**SUBJECT:** Unloader change

The MV520 unloader is discontinued by the manufacturer and is replaced with a new model: VR54.

January 2013

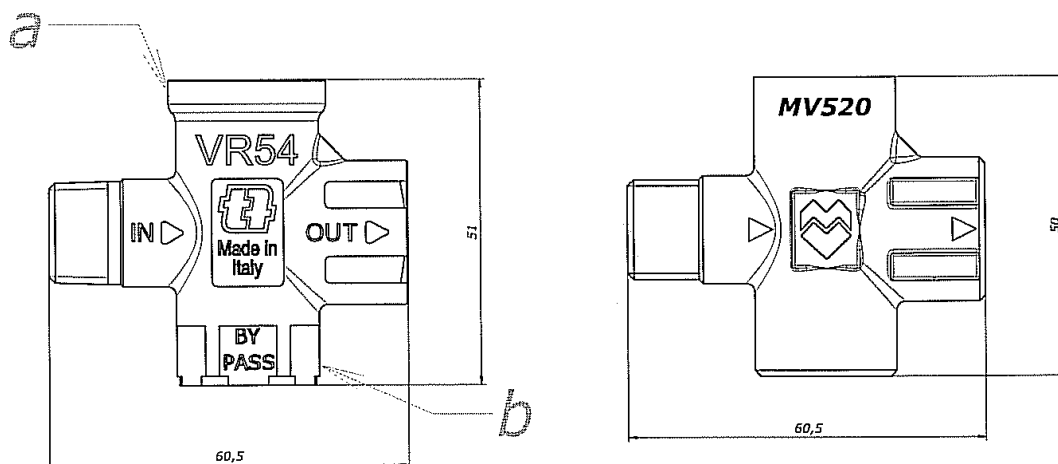
MV changed the forging on their unloader. MV is now “Tecomec” due to a merger of two Italian companies.

The new forging has the Tecomec logo, is 1mm taller, 45% stronger, and has a hex body at the bypass port. All internal parts are interchangeable. Rebuild kits are identical. See photo and dimensional drawing attached.

- a.) Collar for higher pressure. Outside diameter = Ø1.05 inches.  
b.) Hex body for easier fitting installation.

Panel Cutout Dimensions:

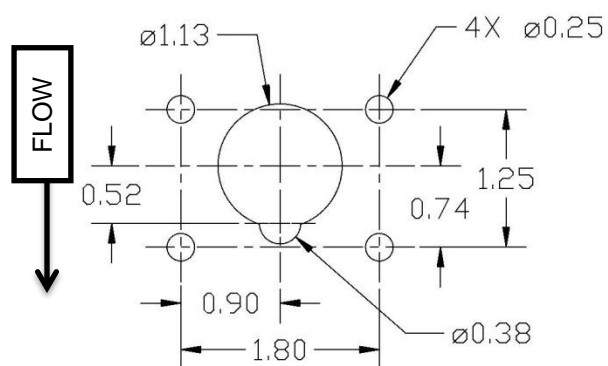
- Pumptec part number remains unchanged
- Cost is same
- All ports are same
- Same black adjusting knob fits both (old and new) models
- Mounting brackets are the same. However panel cutout hole may need to increase. (see cutout dimensions – pg. 2)
